NOTICE OF ERROR
REPLY

Water right number: 29-2300

Quad Ref:
AA-93

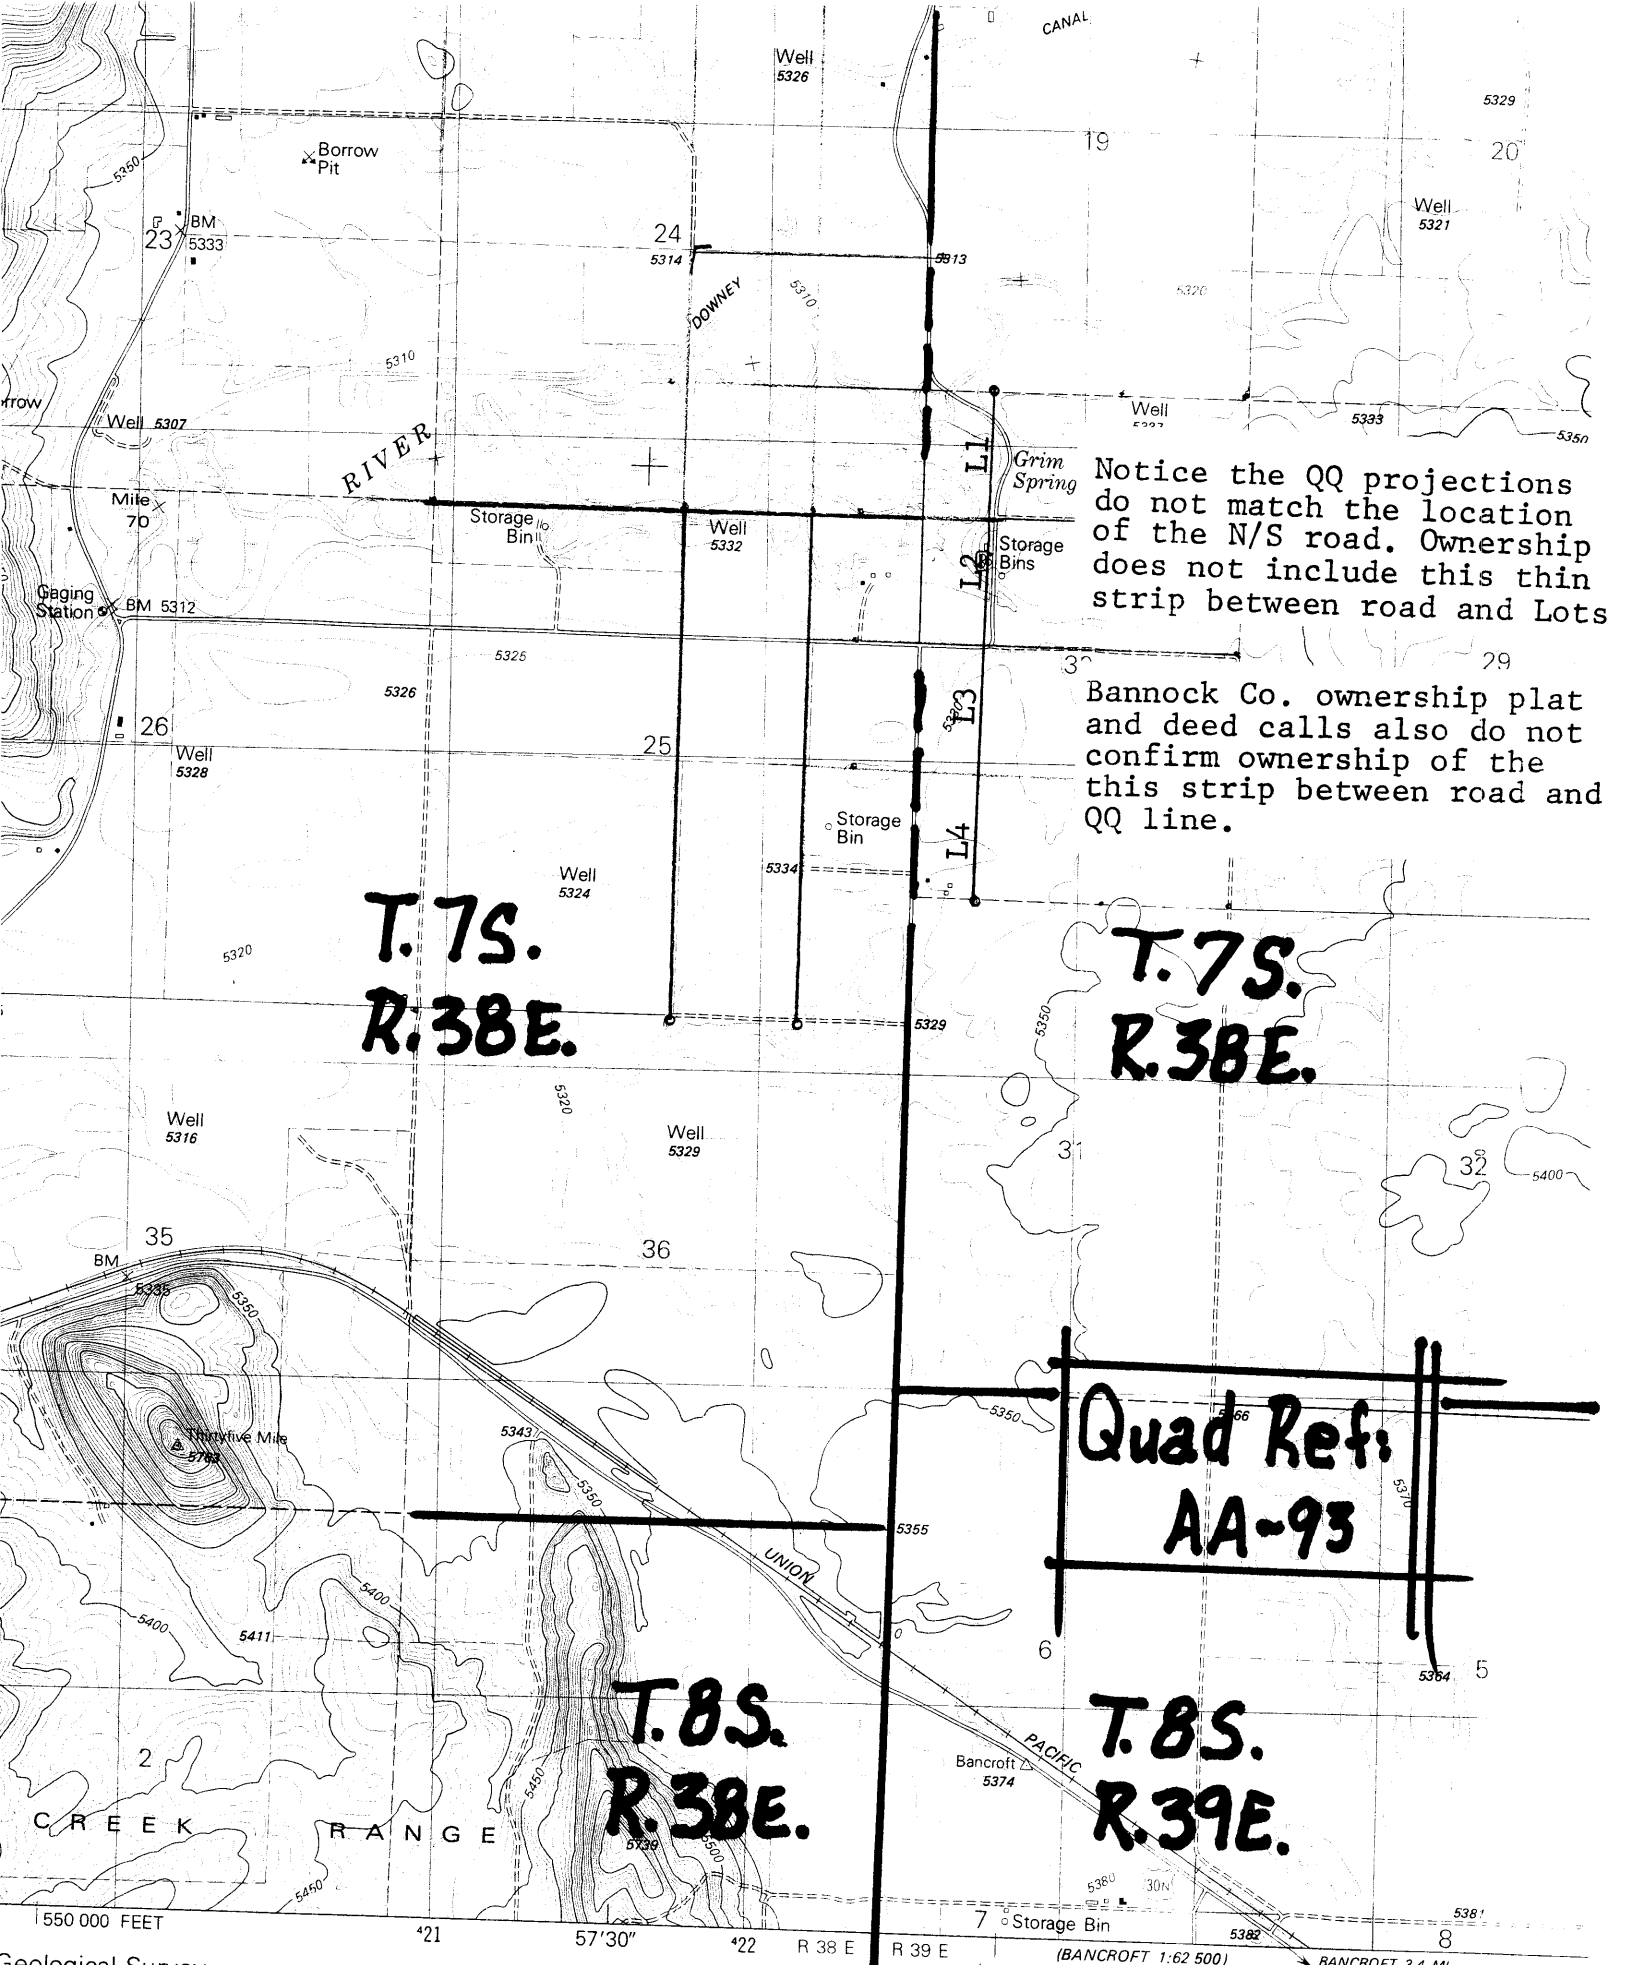
CONNECT PLU BOUNDARY.

Notice the QQ projections do not match the location of the N/S road. Ownership does not include this thin strip between road and Lots

Bannock Co. ownership plat and deed calls also do not confirm ownership of the this strip between road and QQ line.

*G8S RE-EVALUATED - NO BASIC CHANGES TO WR
RECOMM. SLIGHT VARIATION TO PLACE OF USE BOUNDARY.*

SEE ATTACHED ANNOTATED QUAD MAP (REF AA-93)
